**Poplar Cottage, Little Shaw Lane,
Markfield**

**Designer Response to
Stage 1 Road Safety Audit**

STAGE 1 – ROAD SAFETY AUDIT

REPORT REF: 23-1586-RSA1

Figure 2 – Problem Location Plan

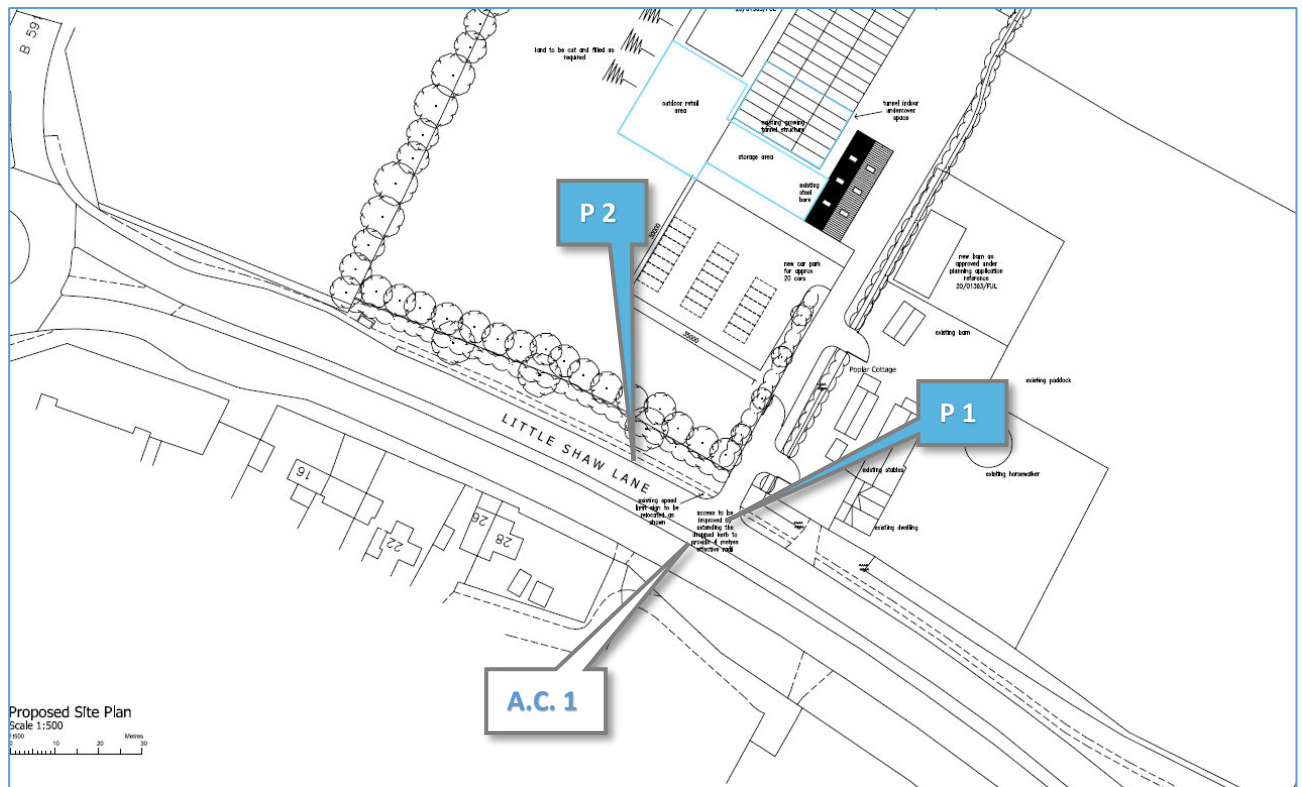
Location: Little Shaw Lane – at the site access.

Summary: Accelerating eastbound vehicles risk collisions with emerging traffic.

Whilst on site it was observed that vehicles exiting the roundabout to the west accelerate quickly towards the site access, which is located on the increase from a 40mph speed limit at the junction to a 50mph limit. As such, gaps in traffic, whilst frequent, can be difficult to judge, especially due to a lack of conspicuity of the access (see Problem 2). There is a concern that this will result in collisions between eastbound traffic and emerging vehicles.

It is recommended that the start of the 50mph speed limit is relocated to the east of the access.

Location: Little Shaw Lane – at the site access.

Summary: Lack of site awareness may lead to hesitancy and shunt type collisions.

The site access is currently inconspicuous. The change to allow public access will result in some drivers who are unfamiliar with the site visiting. The lack of awareness of the site may result in hesitation and / or late braking, risking shunt type collisions on Little Shaw Lane.

It is recommended that additional measures are provided to alert drivers to the site location. This could be either within the highway or at the site frontage / access.

The site access has visibility splays well in excess of those required, not only will drivers of vehicles exiting the site be able to see approaching traffic as they negotiate the roundabout, drivers of the vehicles approaching on the A511 will be able to see vehicles leaving the access as they leave the roundabout approximately 160 metres away. The following photograph shows the excellent visibility out of the access to see vehicles approaching the access:-

It is therefore felt that as a result of the excellent visibility splays well in excess of normal standards and given the frequent large gaps in traffic flow that relocating the speed limit signs to the eastern side of the access is not necessary. However if this is considered an issue by the Local Highway Authority, then the applicant would be prepared to pay to have the speed limit signs relocated to the eastern side of this access.

Recommendation accepted. The applicant would be happy to cut back the vegetation on the site frontage, and to relocate his existing sign to the western side of the access.

This will make the access more conspicuous for drivers as they leave the roundabout. The following photograph shows the existing sign which is currently located on the eastern side of the roundabout, which will be relocated to the western side of the access, which will mean that the access will become more visible to vehicles approaching the access as they leave the roundabout:-
